MANDATORY SERVICE BULLETIN

NO. MSB-D4-059/1

Type: DA 40 D

Replacement of aileron and flap bellcranks located in the wing, with bellcranks that allow for additional angular movement of the push rods, and replacement of bent rod ends.

Figure 1: Aileron Controls in the Wing (colored items are affected by this SB)

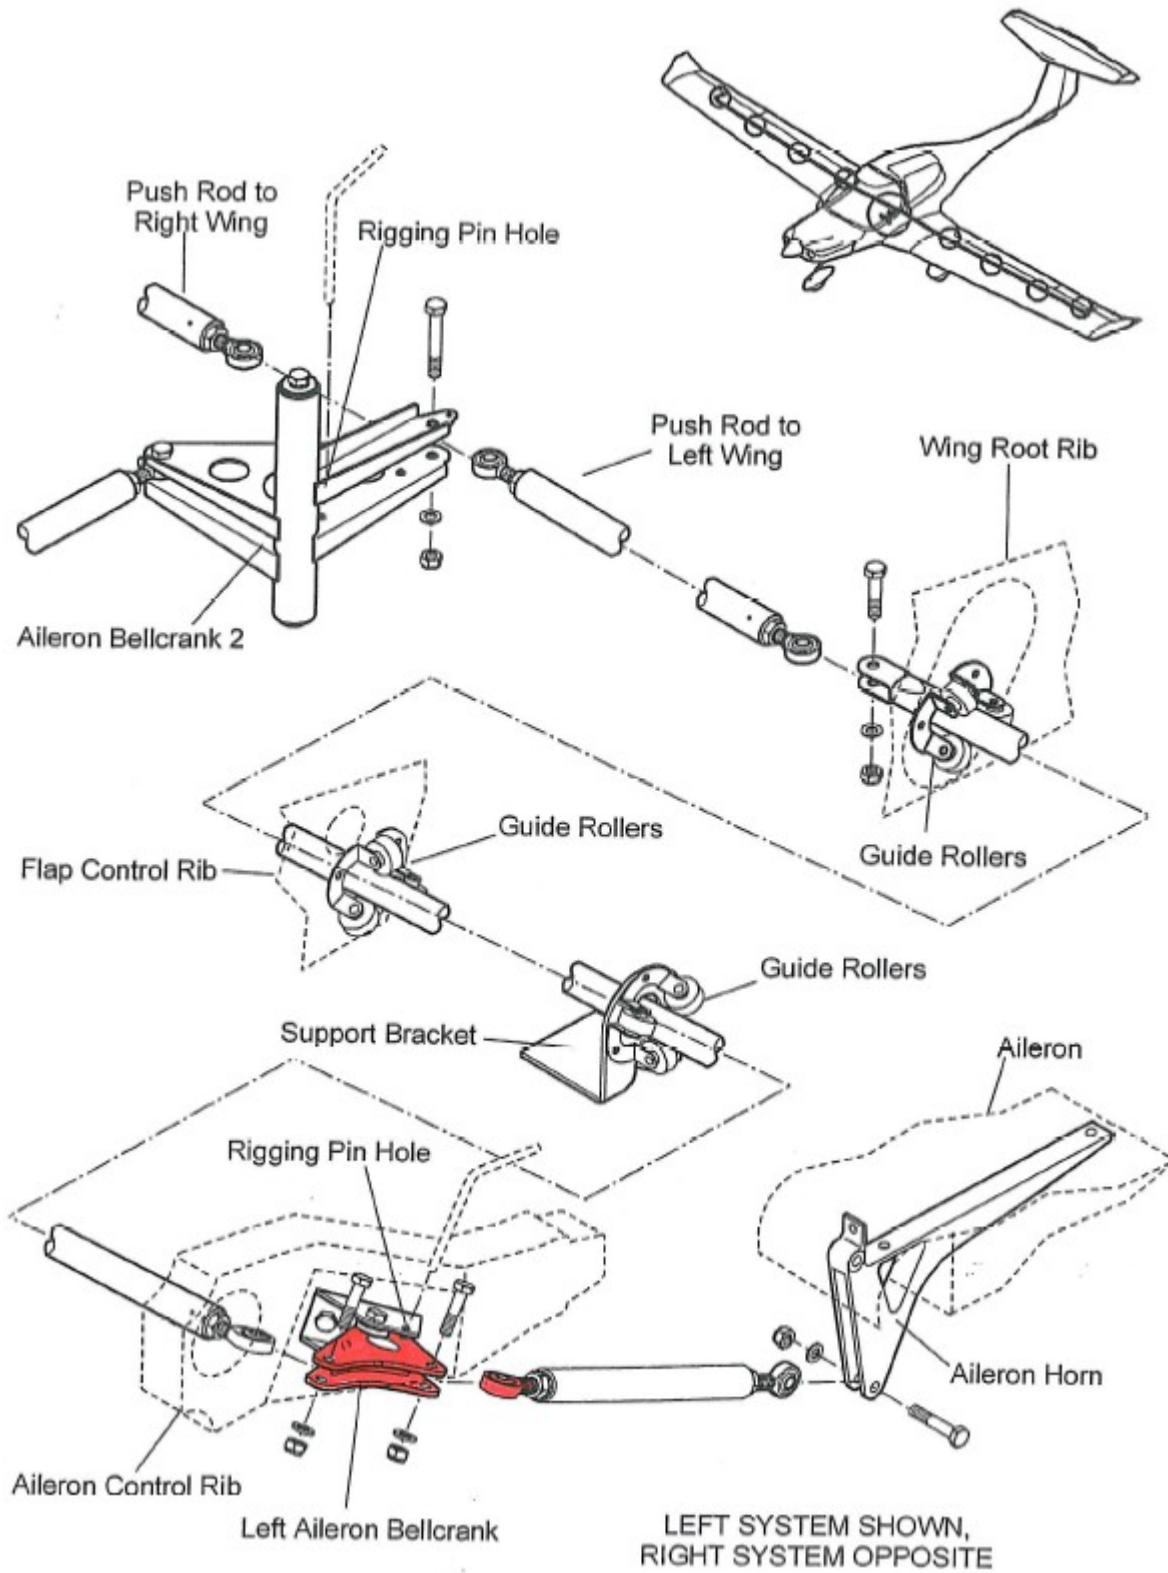
Replacement of aileron bellcrank on all affected airplanes:

1.	Disconnect/Remove aileron push rods from the bellcrank.
2.	Record adjusted length of the short pushrod (from the aileron bellcrank to the aileron horn).
3.	Replace aileron bellcrank, refer to AMM section 27-00-00. NOTE: Keep bolt and washers, replace self-locking nut.
4.	Replace bent rod end (eye-end fitting with spherical bearing) and adjust to correct length, refer to AMM section 27-00-00. CAUTION: The thread of the rod end must be in safety.
5.	Install Bonding Sheet and reconnect/reinstall the push rods to the bellcrank using the LN 9037-M6x32 bolt and a new self-locking nut. Refer to DA4-2717-00-00_01 and AMM section 27-10-00.
6.	Clean working area and check for foreign objects.
7.	Repeat items 1 to 6 on the other wing.
8.	Perform aileron system test procedure, refer to AMM section 27-10-00.
9.	Test all systems in working area for function.

Figure 2: Flap Controls in the Wing (colored items are affected by this SB)

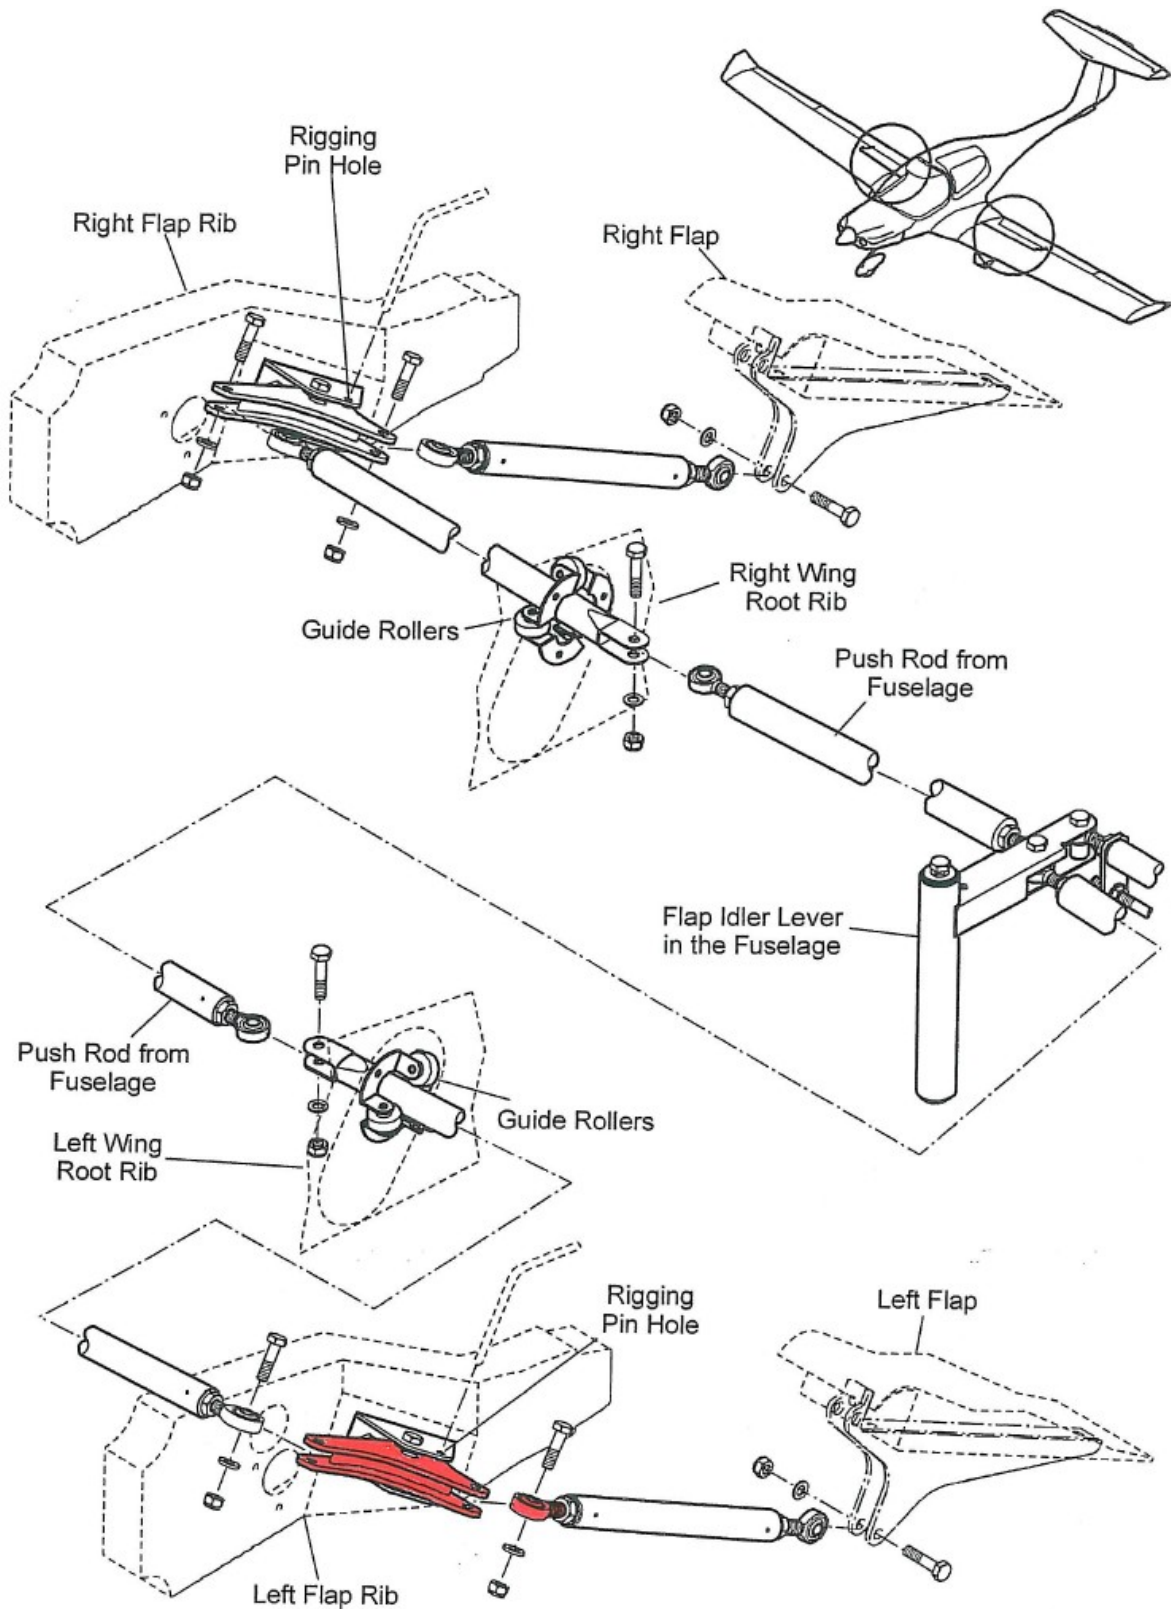
Replacement of flap bellcrank, only for airplanes with serial number 40.080, 40.084, D4.001 through D4.188, D4.190 through D4.238, D4.240 through D4.252, D4.255 through D4.261, D4.263 through D4.272, D4.274 through D4.278, D4.281, D4.288 (MÄM 40-300 through MÄM 40-300/f not carried out in production):

10.	Disconnect/Remove flap push rods from the bellcrank.
11.	Record adjusted length of the short pushrod (from the flap bellcrank to the flap horn).
12.	Replace flap bellcrank, refer to section AMM section 27-00-00. NOTE: Keep bolt and washers, replace self-locking nut. NOTE: In order to remove the bolt holding the bellcrank, it may be necessary to loosen or remove the bolts holding the pedestal to the rib. If so all loosened or removed bolts must be installed properly after installation of the new bellcrank!

13.	Replace bent rod end (eye-end fitting with spherical bearing) and adjust to correct length, refer to AMM section 27-00-00. CAUTION: The thread of the rod end must be in safety.

14.	Reconnect/Reinstall the push rods to the bellcrank using the LN 9037-M6-28 bolt and a new self-locking nut.
15.	Clean working area and check for foreign objects.
